PCN Title: Qualified Additional A/T Sites and Bill of Materials (BOM)

PRODUCT CHANGE NOTICE

PCN-2501 REV 1

TSOT26 Changes:

Current Package Outline Drawing (POD)

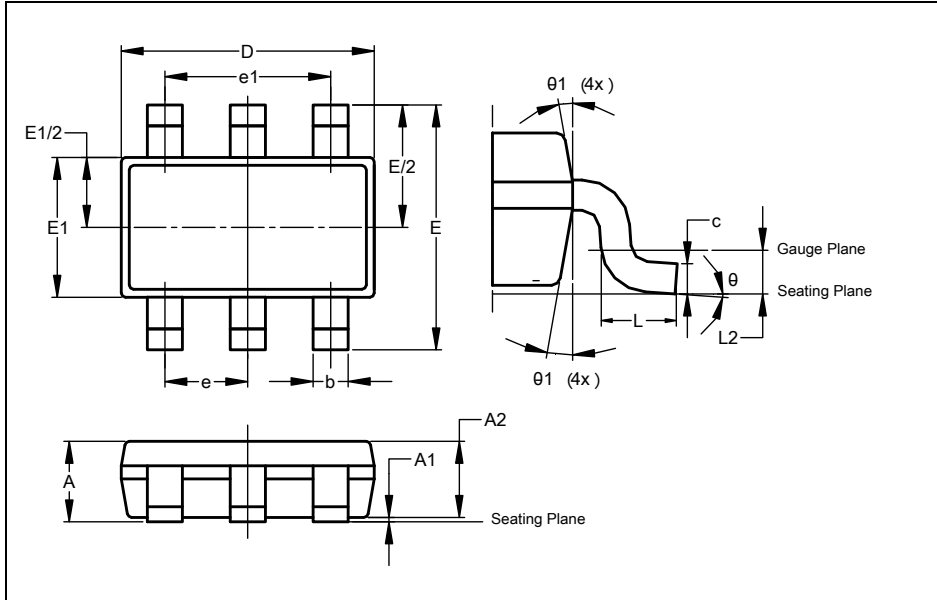
The minimum value of Dimension A2 decreased from 0.84mm to 0.75mm.
 The minimum value of Dimension D decreased from 2.8mm to 2.7mm while its maximum value increased from 3.0mm to 3.1mm.
